**ADDENDUM FOUR  
NORTH ST ELMO DRAINAGE SYSTEM STUDY AND UPGRADE  
CONTRACT NUMBER S-09-008-201  
CITY OF CHATTANOOGA, TENNESSEE**

The following changes shall be made to the Contract Documents, Specifications, and Drawings:

CONTRACT NUMBER:  
 S-09-008-201  
 DATE: 03-29-2016  
 SHEET 21C OF 28

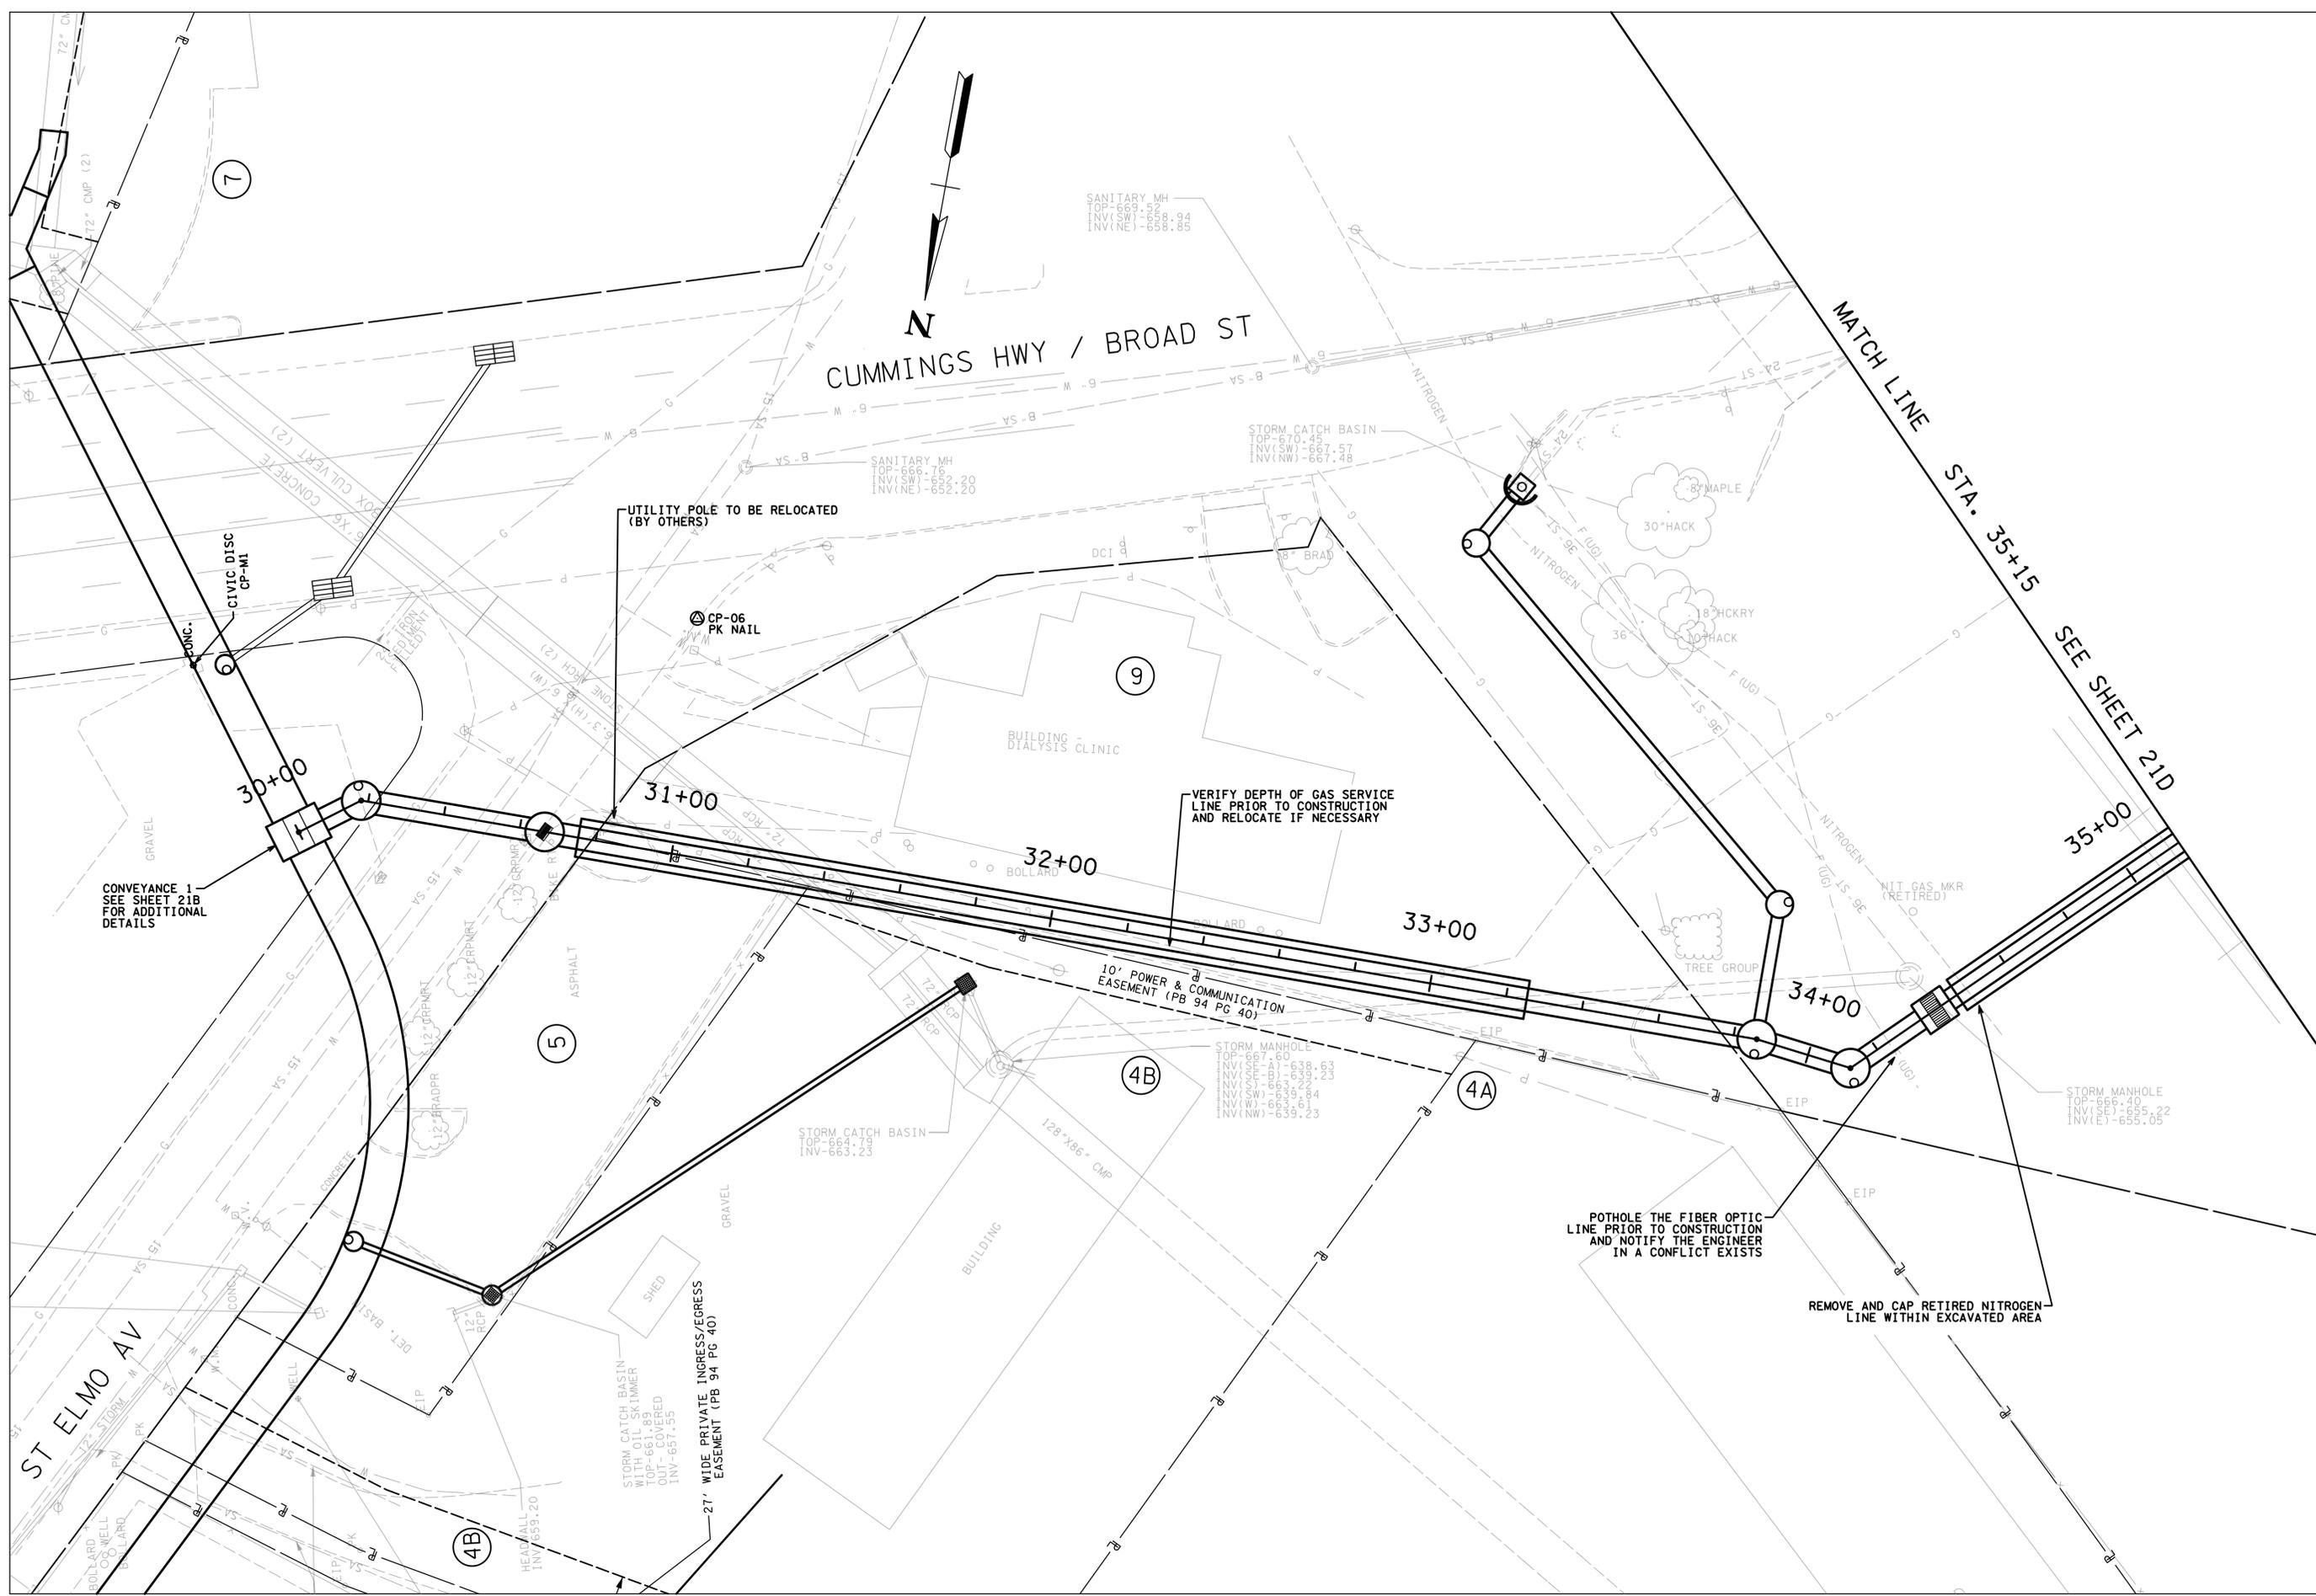
8. **On sheet 21 and 21C in the plans the note for the Nitrogen Line calls for the line to be refilled with nitrogen; however, Appendix D in the specifications does not mention refilling the lines. Is the refilling of the lines done by Linde, Inc.?** The City of Chattanooga has verified that the abandoned pipelines associated with the Linde, Inc. site are not pressurized and have only a small amount of water in one line at the time of the investigation. The City of Chattanooga is currently having the water tested to determine if it is contaminated and requires special handling and disposal. Appendix D has been revised and is attached to this addendum and describes how the abandoned pipelines should be handled under this contract. If testing shows that the water in the pipeline is not contaminated and can be pumped into surface water or into the sanitary sewer, the payment for this work shall be included in item 001-7 “Dewatering operations”. If testing shows that the water in the pipeline is contaminated, an allowance has been created in the bid schedule to compensate the contractor for removal and disposal of the water in accordance with all local, state, and federal laws and regulations.

DATE	REVISION DESCRIPTION
4-20-16	REVISED NITROGEN LINE NOTE

CONTRACT NUMBER: S-09-008-201  
 DATE: 03-29-2016  
 SHEET 14 OF 28

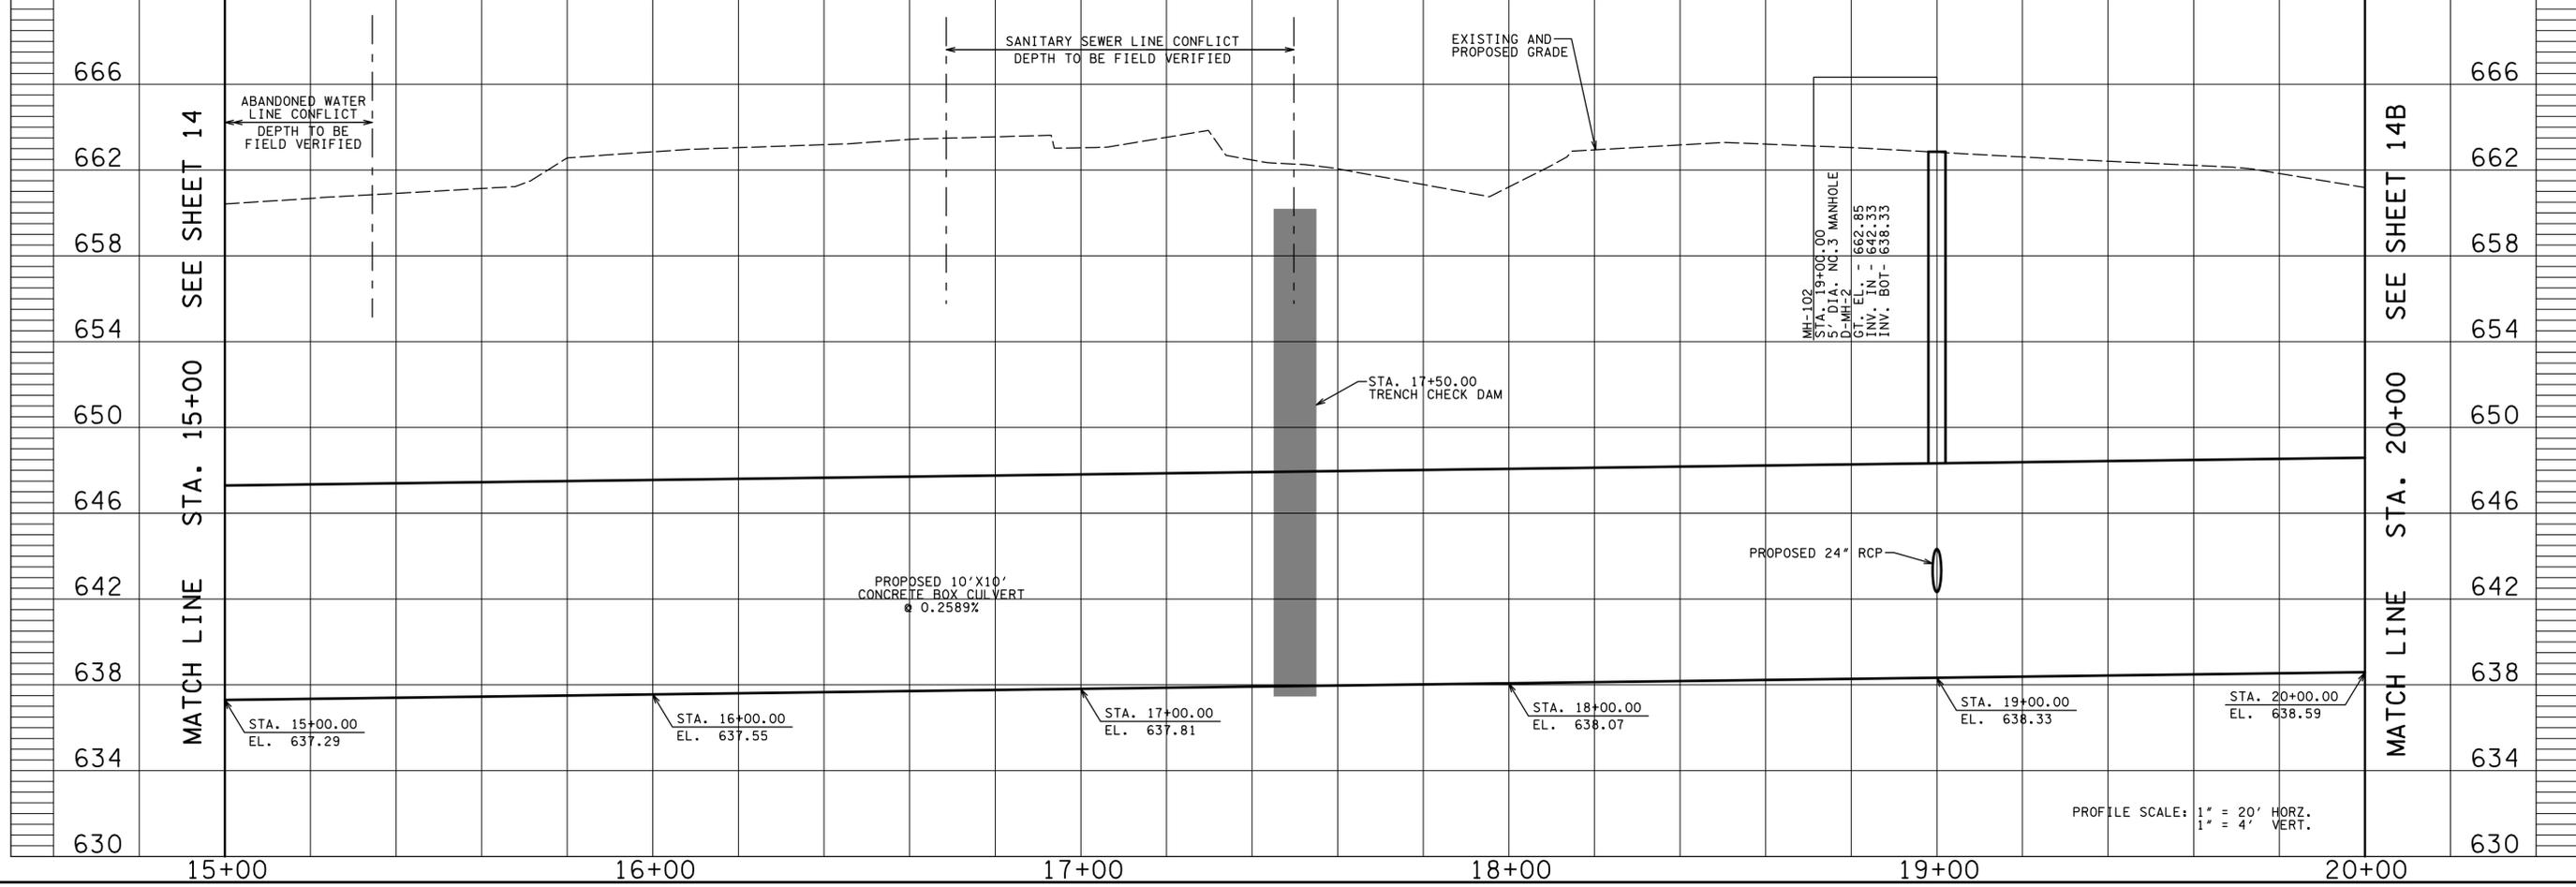
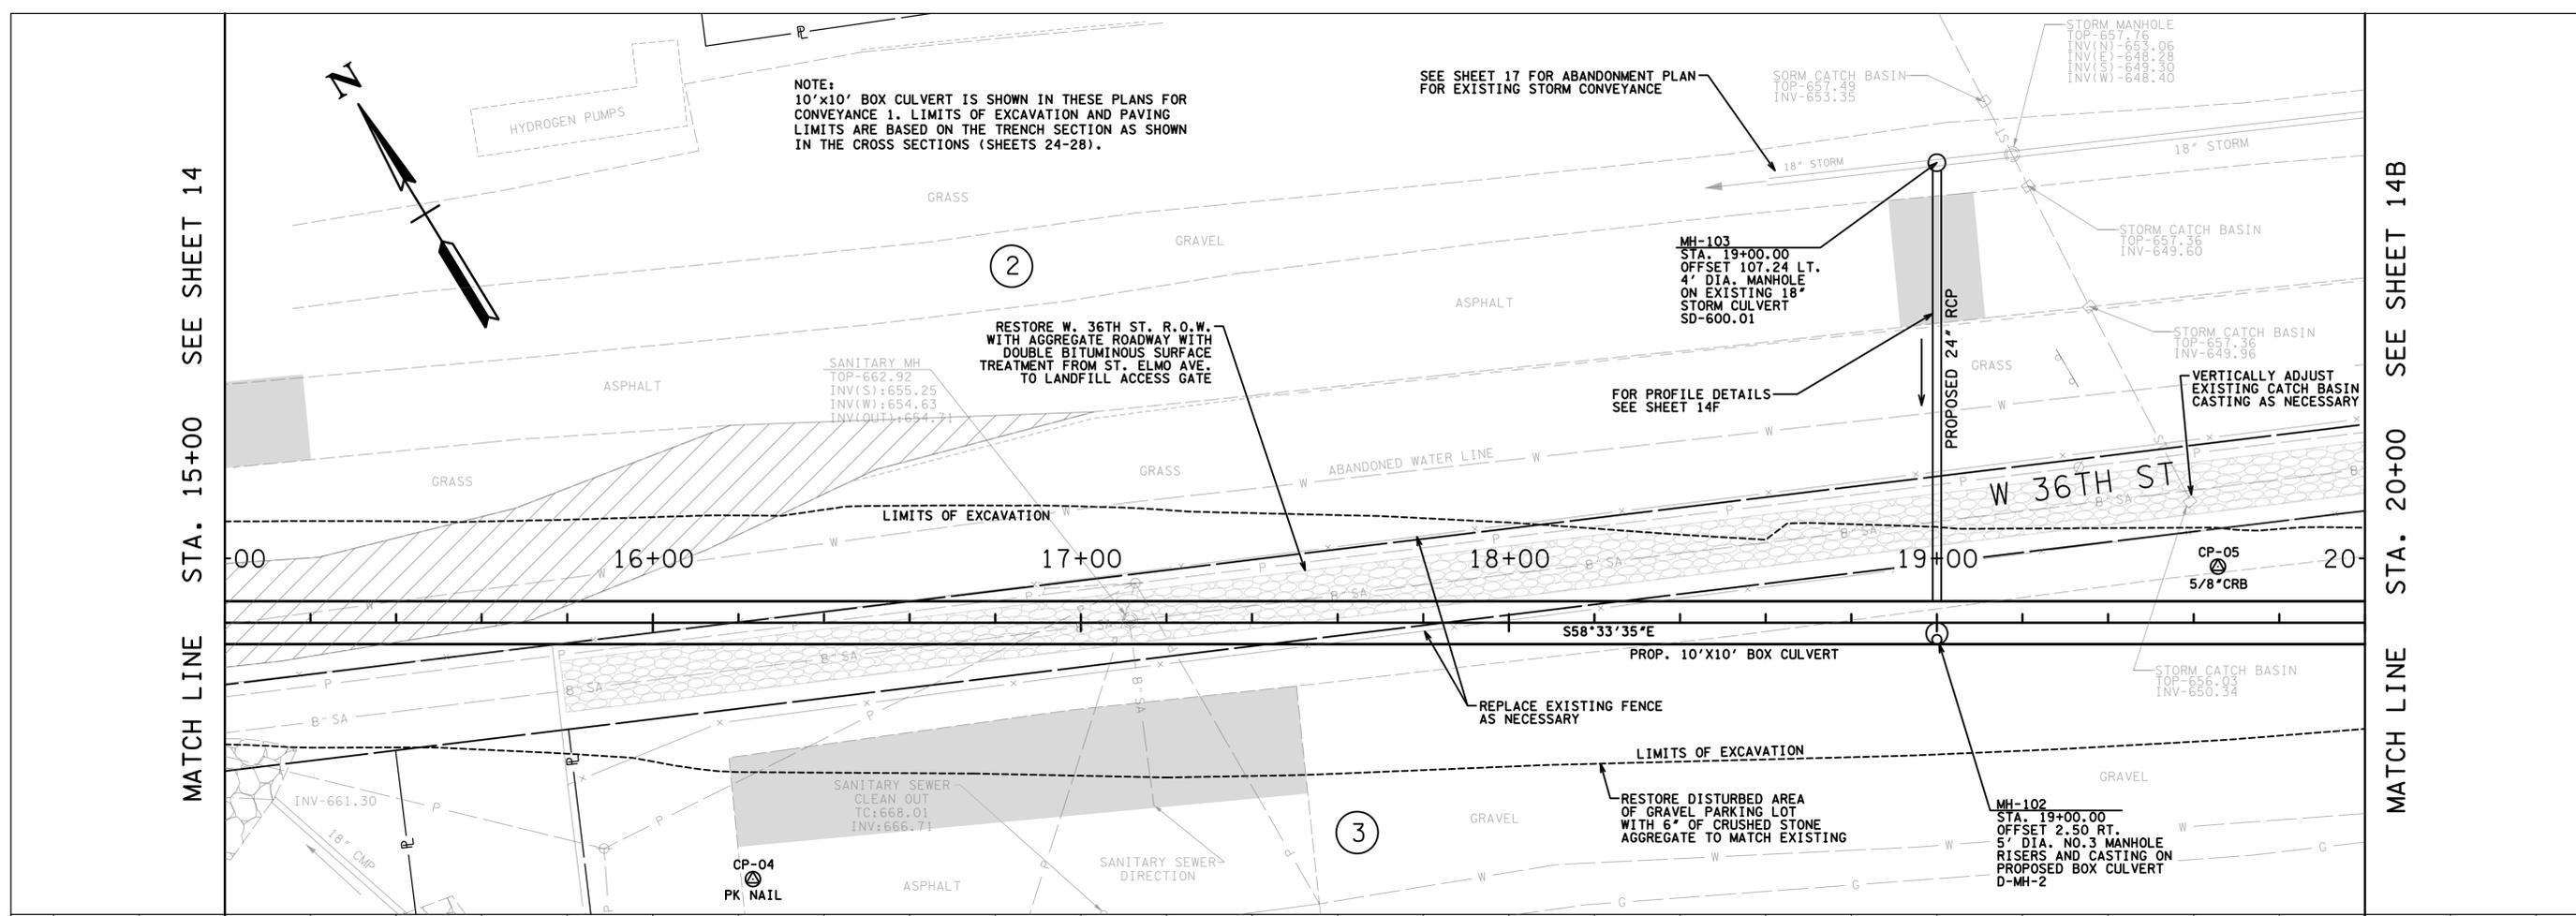
2. **Sheet 14B – Existing wells to be relocated – this plan sheet does indicate two existing wells to be relocated. Does the owner have any information on the existing wells, where they need to be relocated to, and what parameters / dimensions need to be adhered to? Are any of the quantities for this work included in bid items SP-05 thru SP-09? One well is indicated as a geothermal pump / well? Is this in fact a geothermal well? Do you (the engineer) have specific details for this particular well because geothermal wells have different requirements from standard monitoring wells?** See the response to question 1 above for additional details. The wells will be relocated as close to their existing locations as possible. The exact location will be coordinated with the property owners and TDEC during construction. The new locations of the wells are not anticipated to be farther than 40 feet from their existing locations. All work associated with abandoning existing wells and

installing new, functional wells should be included in items SP-05 thru SP-08. It has been verbally confirmed by the property owner of Tract 4B that the well is a geothermal well; however, no additional details other than the approximate depth of 350 feet could be provided.

CONTRACT NUMBER:  
 S-09-008-201  
 DATE: 03-29-2016  
 SHEET 14G OF 28

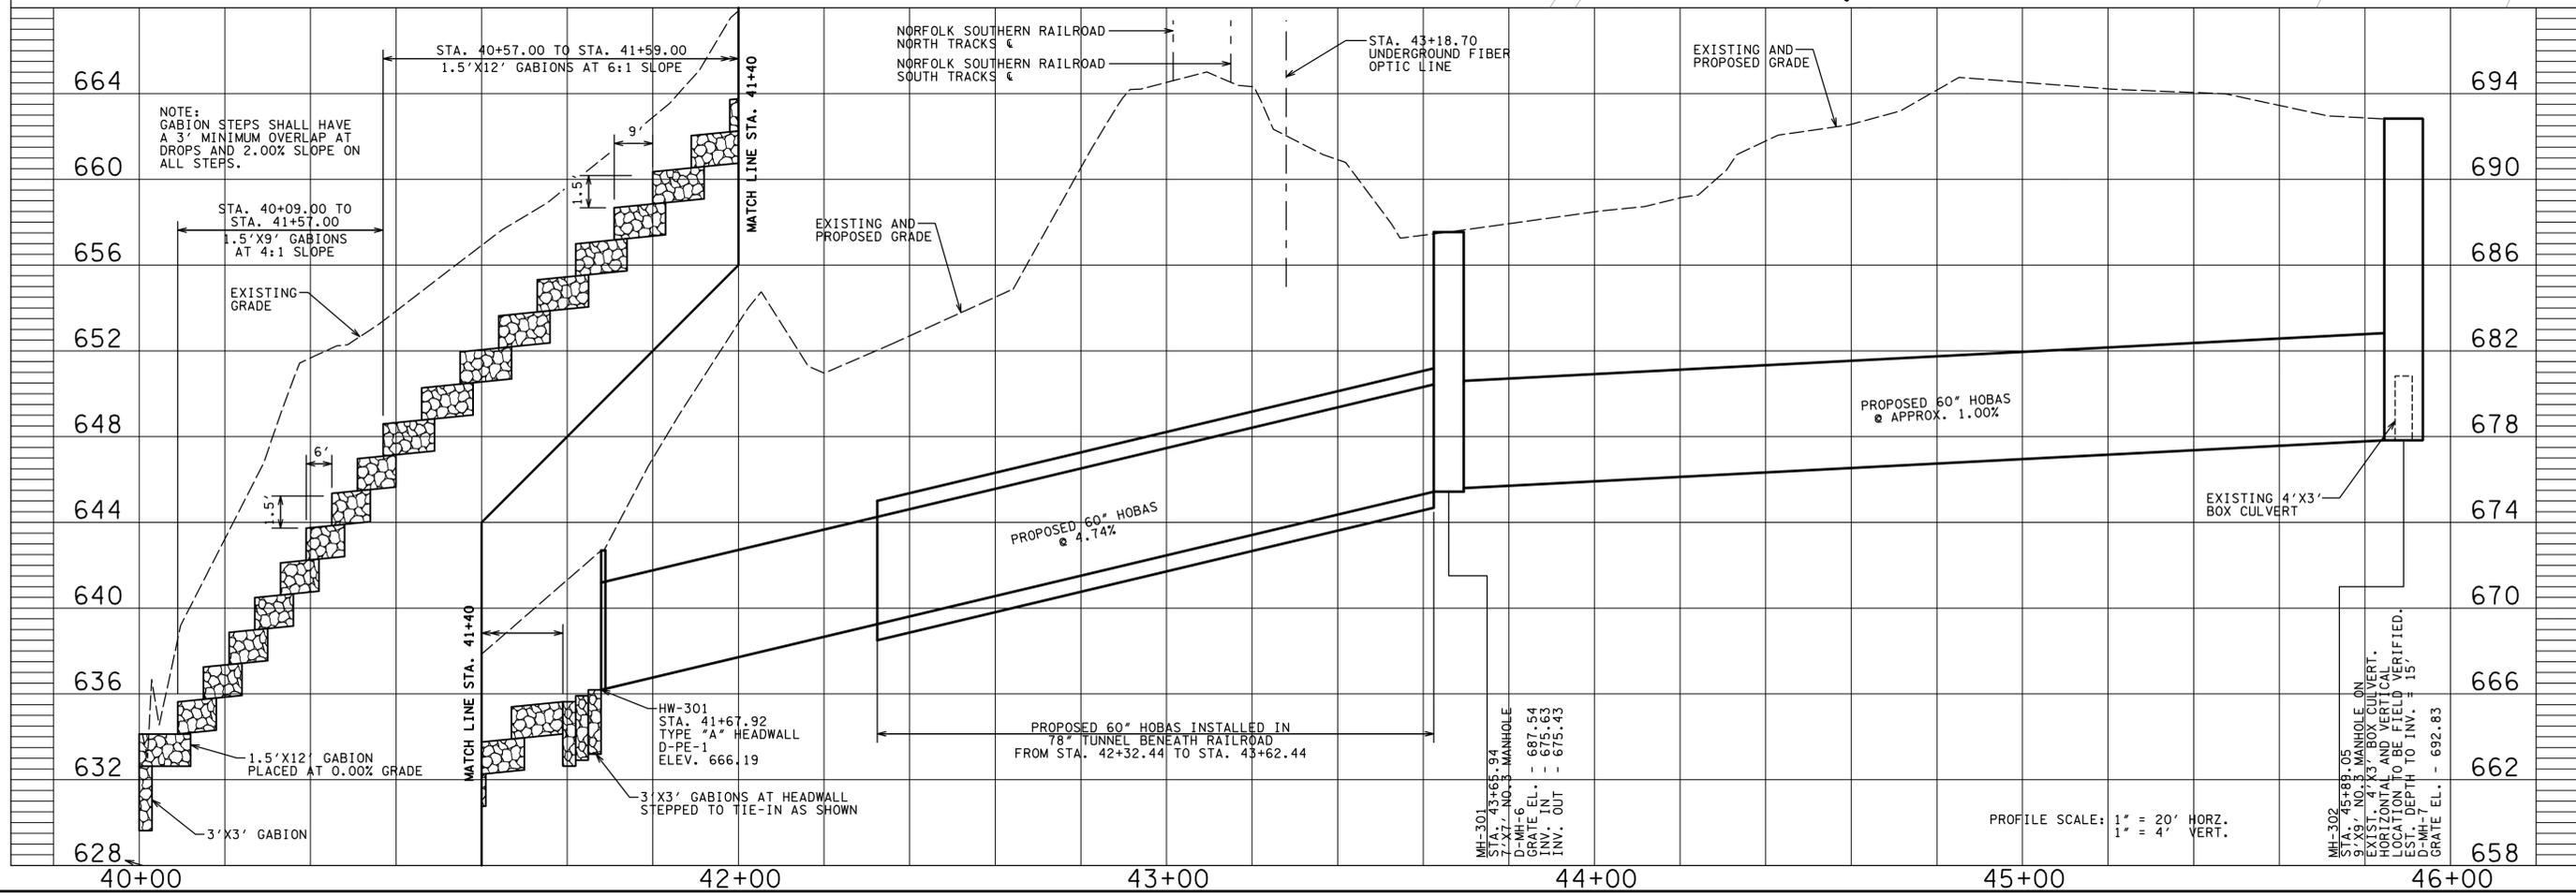
DATE	REVISION DESCRIPTION
4-18-16	CHANGED TUNNEL SIZE FROM 72" TO 78"
